INVENTORY & EVALUATION

SITUATION: Housing development (four lots). See attached diagram.

Diagram of Joe Schuck Housing Development on Stevens Road, Augusta, Maine 04330
(Not to scale)

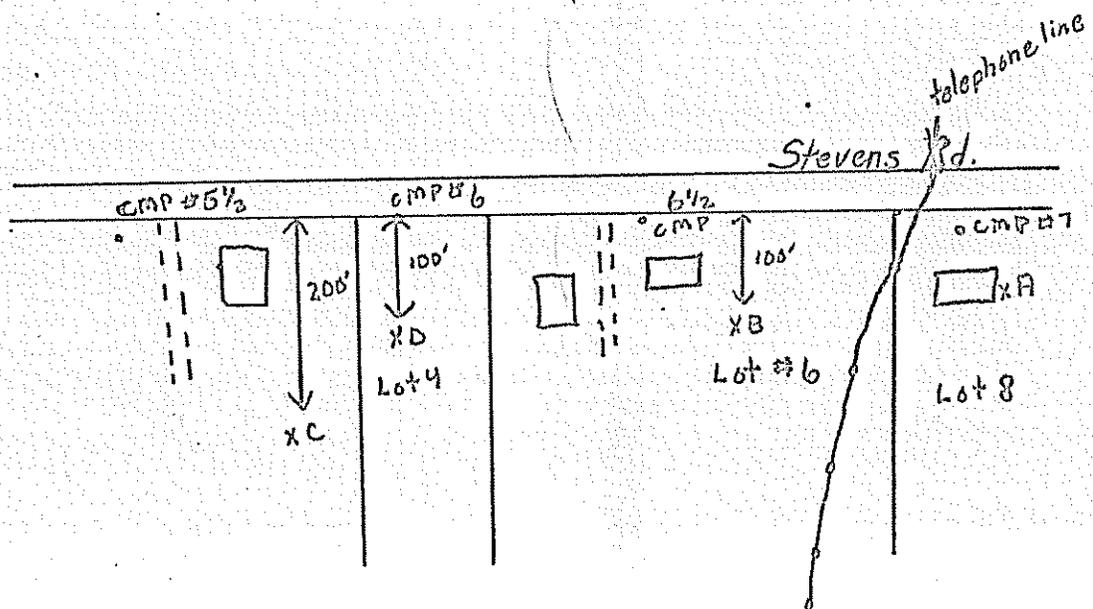
Pit A - Charlton Fine Sandy Loam - B (3-8%) slope, 40" to high water table.

This soil is rated good for Septic Sewage as per "Soil Suitability Guide For Land Use Planning in Maine" Misc. Pub. 667, Me. Agr. Exp. Sta. 2-67, should have 20" of fill to give five feet as stated below:

Pit B - Sutton Fine Sandy Loam. B (3-8%) slope.

Pit C - Sutton Fine Sandy Loam. B (3-8%) slope.

Pit D - Scantic ^{Silt} ~~Fine Sandy~~ Loam. B (3-8%) slope.

Sutton FSL rated poor as per above. Pits B & C have an impervious layer at 18" & 31" respectively. Plumbing Code states there must be five feet of depth without impervious layer.

Scantic Silt Loam is rated very poor as per above. Septic sewage systems should not be installed on Lot # 4.

SUGGESTED SOLUTION(S): Could possibly develop effective Septic Sewage fields in these two lots if (H-3) and (H-6) pgs. 36& 37 of the Maine Plumbing Code were followed. Would need to fill at least three & one half feet on Lot # 6 and two and one half feet on lot # 1A.
